Service Bulletin

Bulletin No.: 24-NA-156

Subject: Information on Dealer Installed Accessory Trailer Hitch Installation Concern

6692657

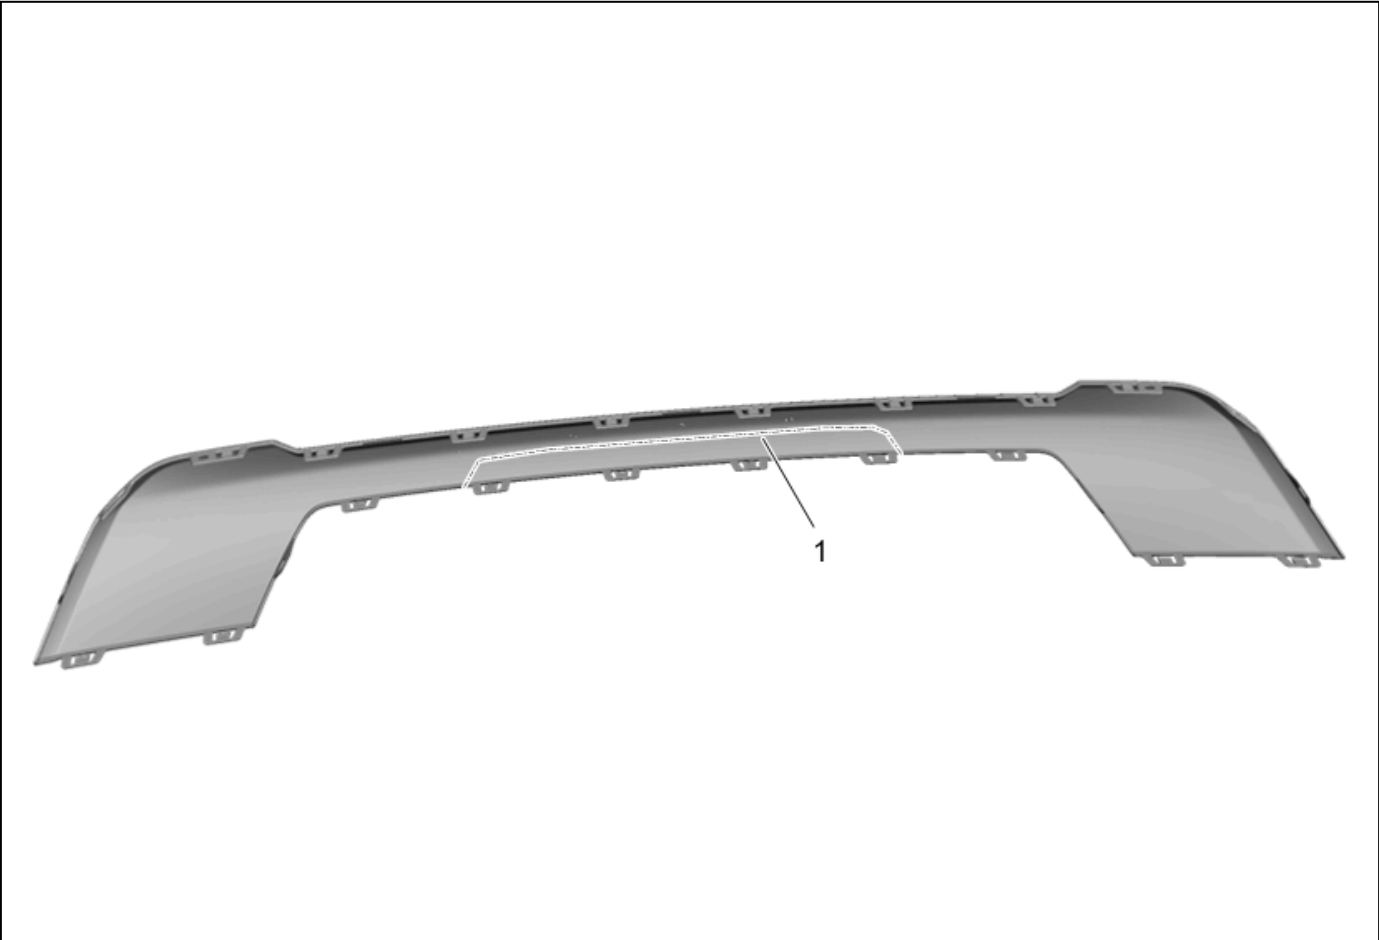
Involved Region or Country	North America
Additional Options (RPOs)	Equipped with Package Option 1LT, 2LT, or 3LT, RPOs SDE and SDR
Condition	During the installation process, dealers may find that the scribe lines may not be present for cutting.
Cause	The supplier removed these necessary lines by mistake.
Correction	If the vehicle is found to not have visible scribe lines, please follow the direction below.

During Installation, on the inside of the rear fascia skid plate, check to see if there is a scribed line (1) present in the location shown. If no scribed line is present, then a new rear fascia skid plate P/N 85629520 must be ordered before proceeding to the next step.

Dealers will be directed to contact the supplier for P/N 85629520, which will have the scribe lines present. The supplier will send them to dealers free of charge.
